FED. ROAD DIST. NO.	STATE	FED. AID PROJ. NO.	FISCAL YEAR	SHEET NO.	TOTAL SHEETS
HAWAII	HAW.	BR-STP-056-1(35)	2000	C.O. 17	70

WAIKAEA BRIDGE WIDENING

KUHIO HIGHWAY-WAIKAEA BRIDGE WIDENING
Fed. Aid Proj. No. BR-STP-056-1(35)

PARTIAL PLAN
(SHOWING LIMITS OF GRP AT END POST NO. 1)
Scale: 3/8"=1'-0"

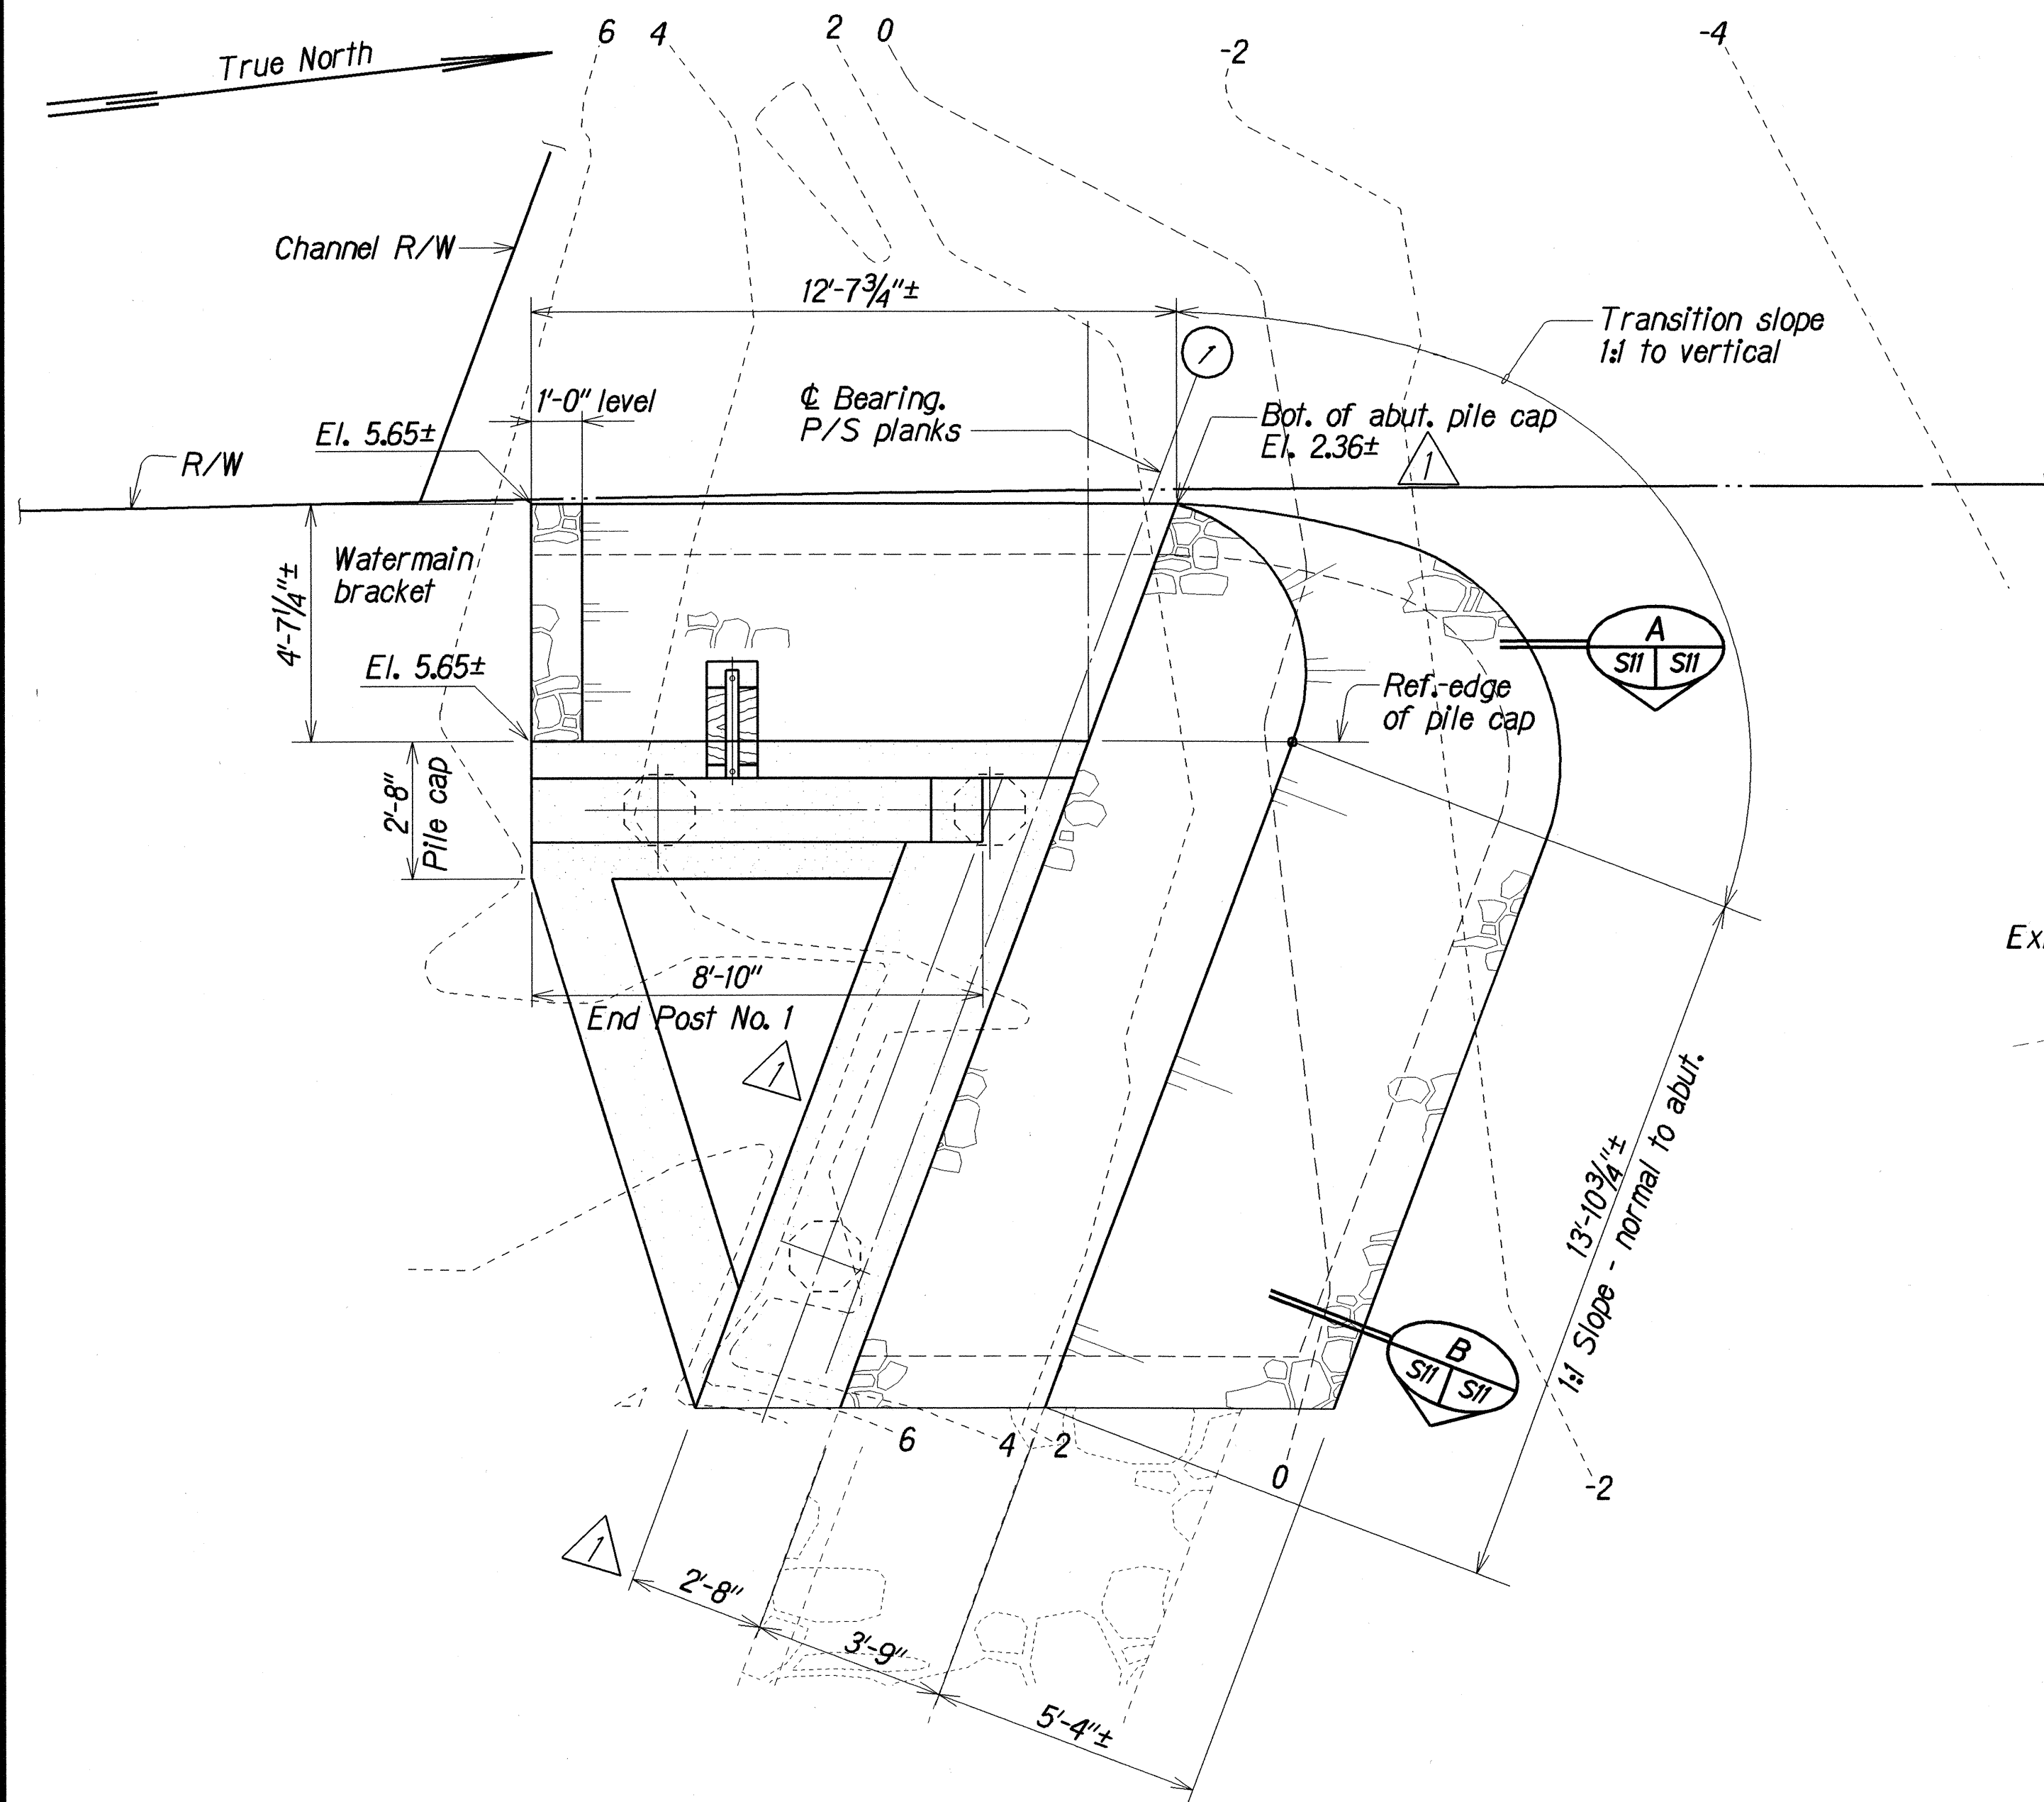
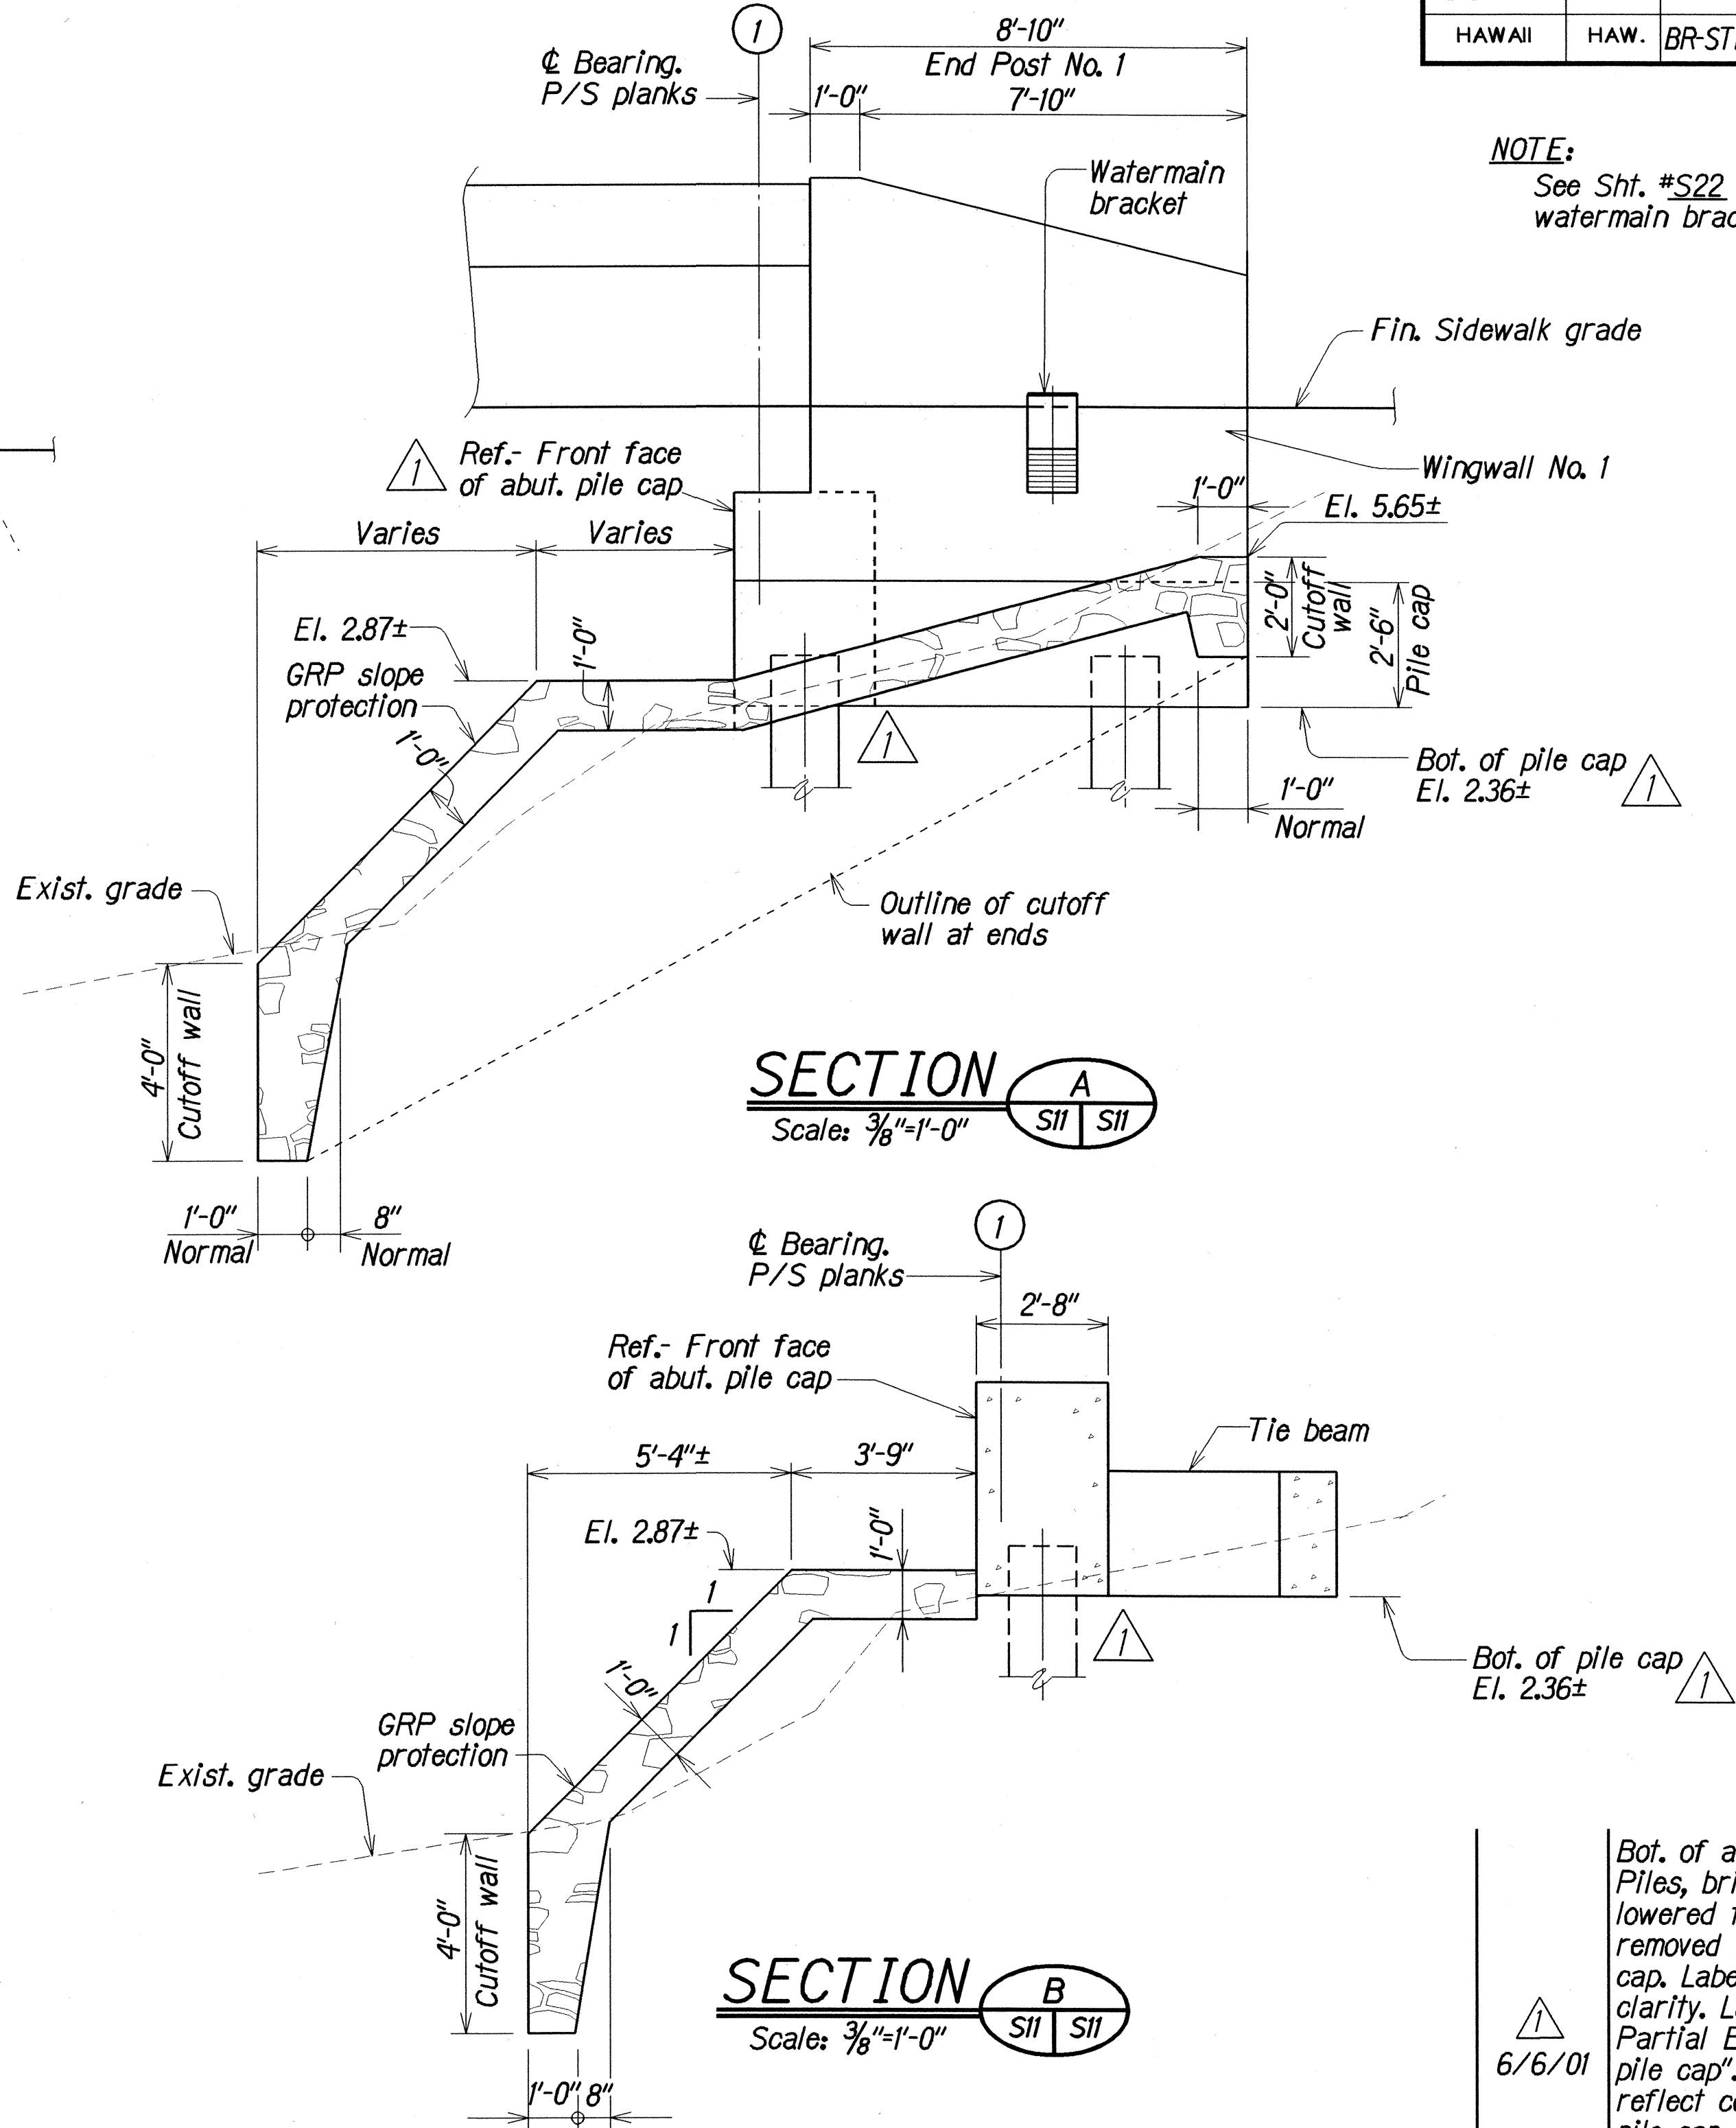
Bot. of abut. pile cap elevation changed.
Piles, bridge, wingwall, & abut. pile cap,
lowered to accommodate changes. GRP
removed behind front face of abut. pile
cap. Labels moved and changed for
clarity. Label reading "Bot. of fig." at
Partial Elev. changed to "Bot. of abut.
pile cap". Pile outline relocated to
reflect correct location and extended
pile cap removed. Note #1 added.
